SOLICITATION AMENDMENT
MODIFICATION DE L'INVITATION

Title - Sujet New 96 Bed Living Unit - PIRTC	
Solicitation No. - N° de l'invitation EZ899-123081/A	Amendment No. - N° modif. 001
Client Reference No. - N° de référence du client	Date 2012-04-24
GETS Reference No. - N° de référence de SEAG PW-\$PWY-005-6657	
File No. - N° de dossier PWY-1-34503 (005)	CCC No./N° CCC - FMS No./N° VME
Solicitation Closes - L'invitation prend fin at - à 02:00 PM on - le 2012-05-08	Time Zone Fuseau horaire Pacific Daylight Saving Time PDT
F.O.B. - F.A.B. Plant-Usine: <input type="checkbox"/> Destination: <input checked="" type="checkbox"/> Other-Autre: <input type="checkbox"/>	
Address Enquiries to: - Adresser toutes questions à: Pillay, Sal (PWY)	Buyer Id - Id de l'acheteur pwy005
Telephone No. - N° de téléphone (604) 775-9386 ()	FAX No. - N° de FAX (604) 775-6633
Destination - of Goods, Services, and Construction: Destination - des biens, services et construction: CSC - Pacific Institution, Abbotsford, B.C.

The following changes in the tender documents are effective immediately. This addendum will form part of the Contract Documents.

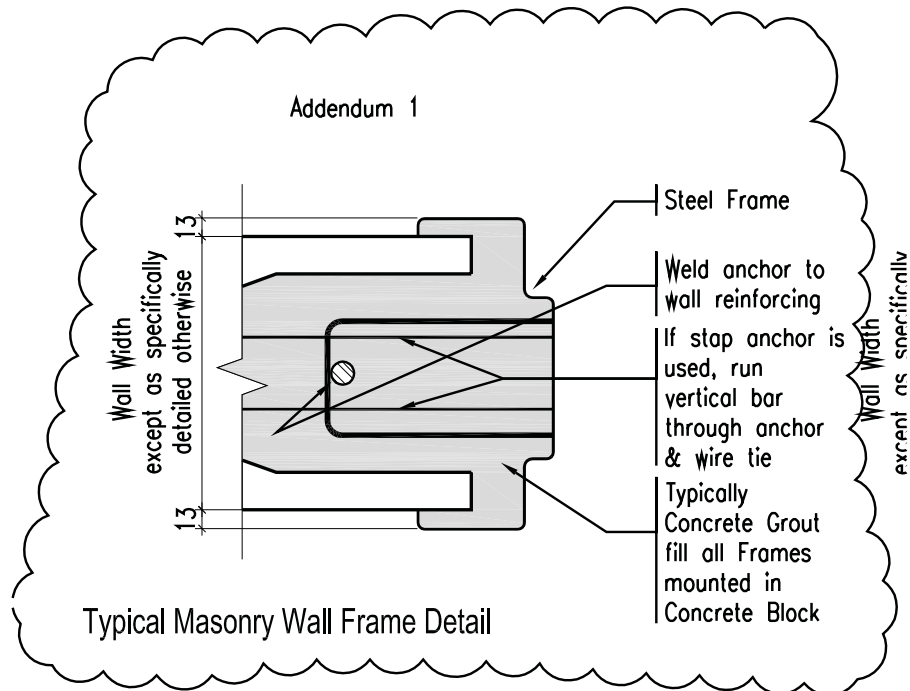
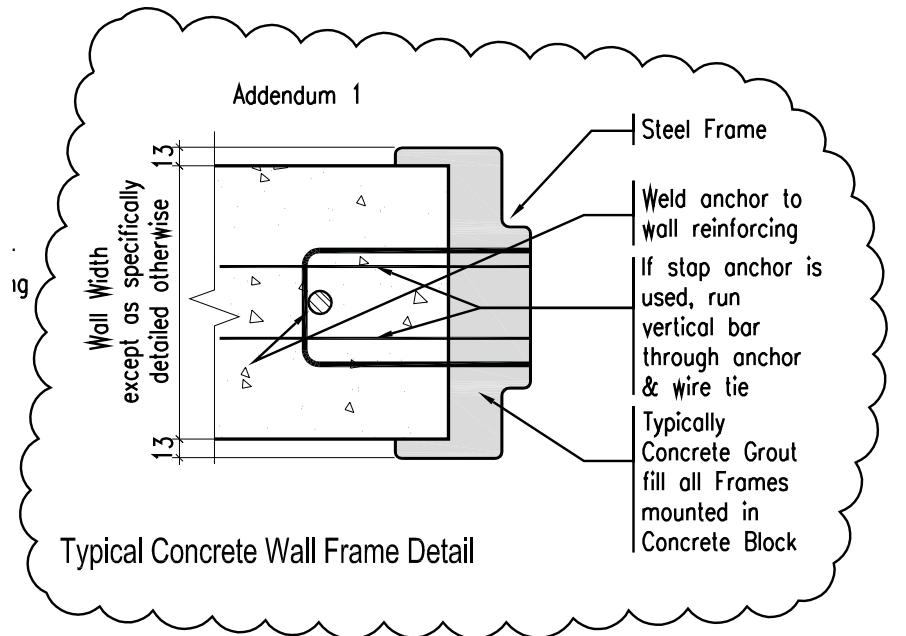
- 5.0 Drawing A703 Section 1 – Added Steel Plate thickness of Steel Curb. Refer to A1-09.
- 6.0 Drawing A900 Revise notes and Frame Detail. Refer to A1-01, A1-02, A1-03.
- 7.0 Drawing A100 Scope of Work to Existing Fence - clarifications Refer to A1-10, A1-11, A1-12 .
- 8.0 Drawing A010 Clarify Scope of new gravel parking pad. Refer to A1-13.

Sheet/Feuille A1-06

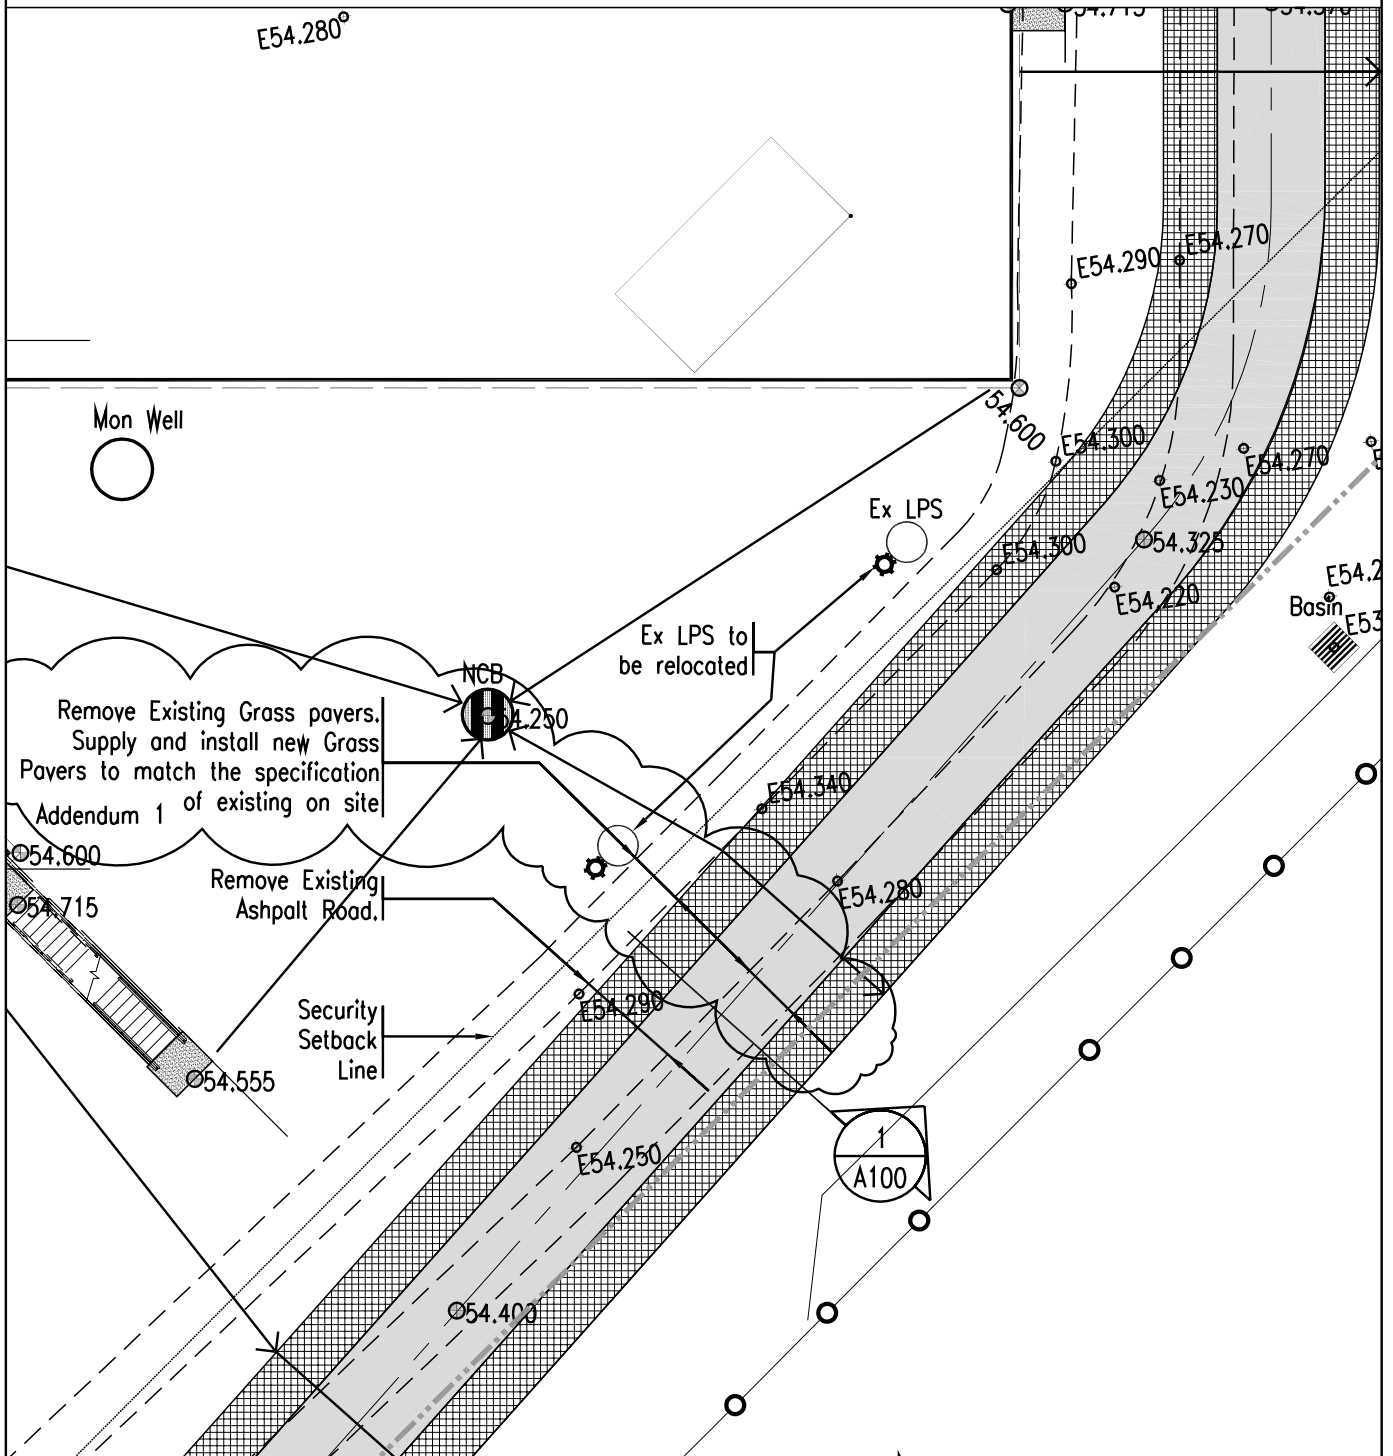
- 1.0 Drawing A100 Delete note to reinstall salvaged pavers. Supply and install new grass pavers. Product specification to match the existing on site for the area designated for grass pavers. Refer to A1-06, A1-07, A1-08.
 - 2.0 Drawing A100 Add gate in fence at fire lane. Refer to A1-04 by Division 11.
 - 3.0 Drawing A200, A201, A202, A203 Revise typical note 13. Refer to A1-05.
 - 4.0 Drawing A407 Room 1038 Kitchette – Revise Counter Construction designation from CT2SP to CT2PS.
-

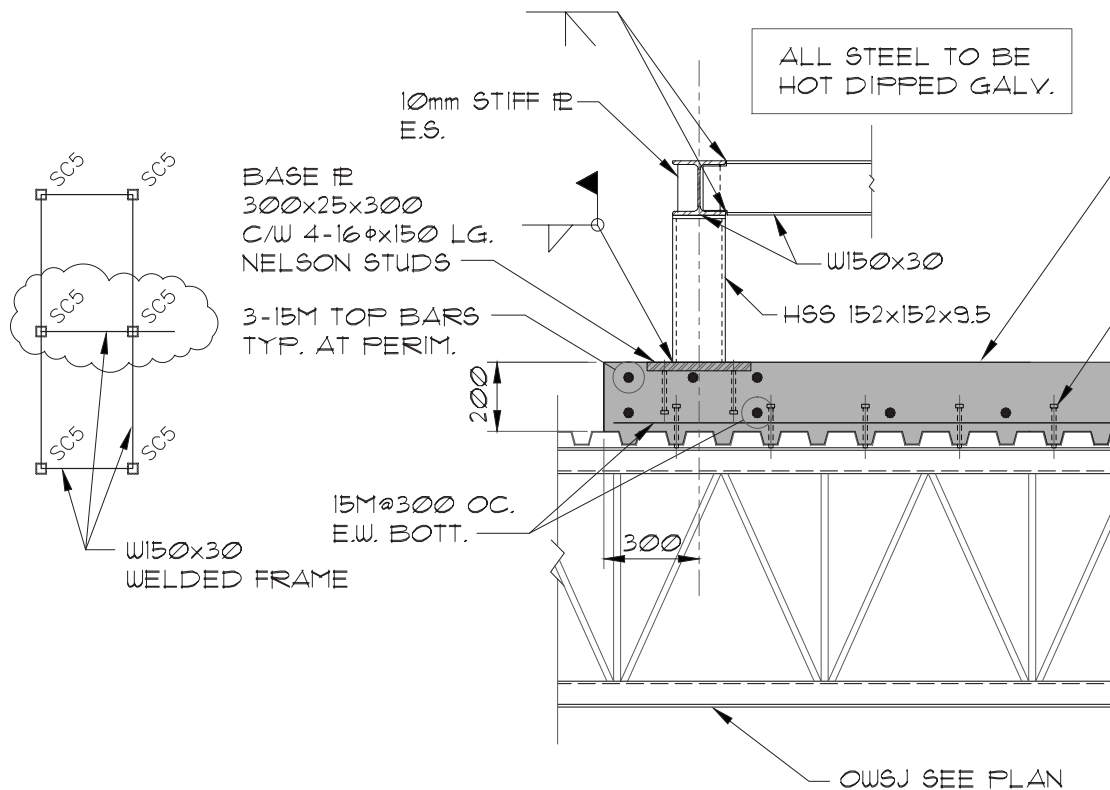
- Where do the W410x46 beams stop?
- How many joists are to be added?

The clouded area is existing framing

DATE 11/04/12	SCALE 1:1	DRN. PKL	CH'D. RH	PROJECT No. BBP 5575
SECTION 20/2.02 REVISED AS SHOWN ABOVE				SHEET No.
ABBOTSFORD, B.C. PACIFIC INSTITUTION REGIONAL TREATMENT CENTRE				SSK-100

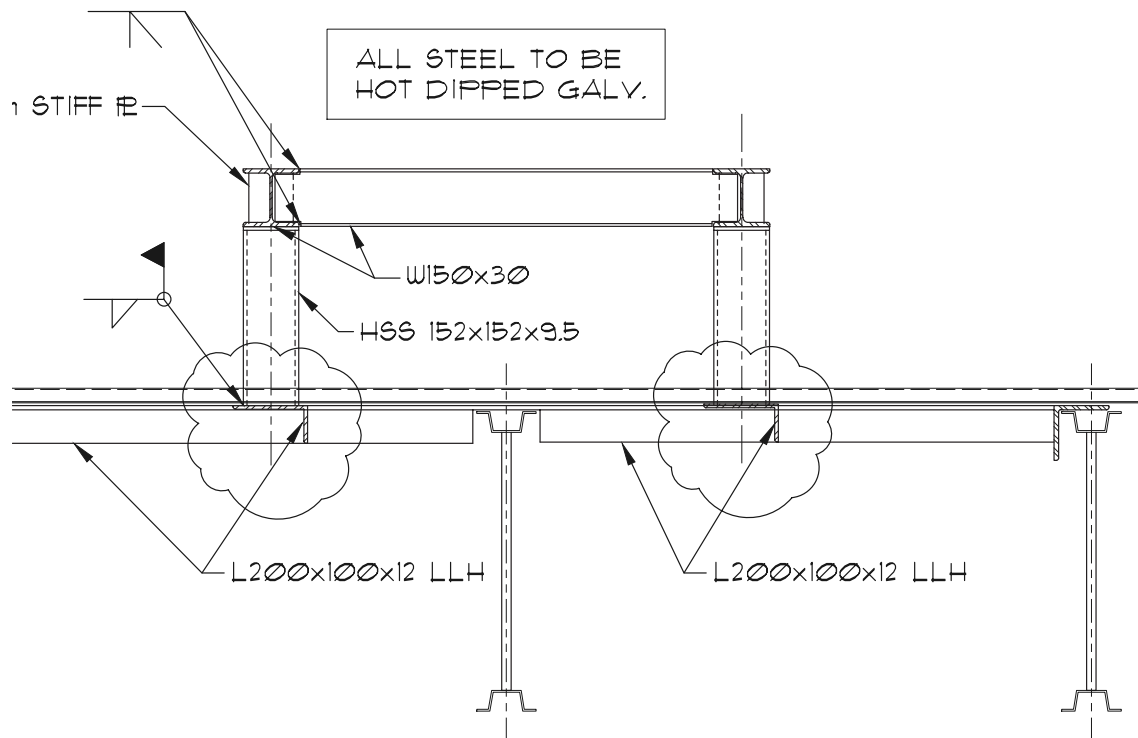
- 1.0 Drawing S1.02 General Notes and Typical Details Sheet 2
 - 1.1 .1 Section 20/1.02 revised as shown. Refer to SSK 100.
 - 1.2 .2 Section 21/1.02 revised as shown. Refer to SSK 101.
- 2.0 Drawing S2.02 Second Floor Plan and Office Area Roof Plan
 - 2.1 Reference to Note 1 added. Refer to SSK 102.
 - 2.2 Reference to Note 1 added and Mech. Unit opening relocated. Refer to SSK 103.
 - 2.3 Location of Note 1 Reference revised. Refer to SSK 104
 - 2.4 Number of Note 1 Locations Changed to 9. Refer to SSK 105
 - 2.5 Mech. Unit opening relocated. Refer to SSK 106
- 3.0 Drawing S2.04 Roof Framing Plan
 - 3.1 OWSJ Schedule Revised. Refer to SSK 107.

MS-2

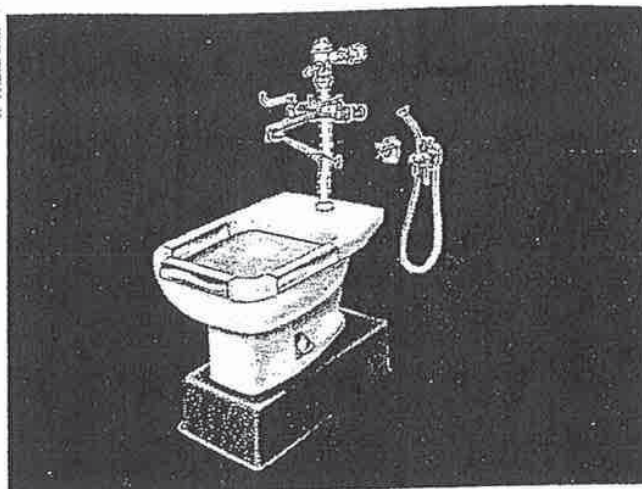
- 1.0 Drawing M2.01 In response to the RFI for make and model # for "MS-3" in room E1004-Jan shown on drawing M2.01. Revise sink label from "MS-3" to "MS-2" and refer to specification cut sheets attached for details of sink.
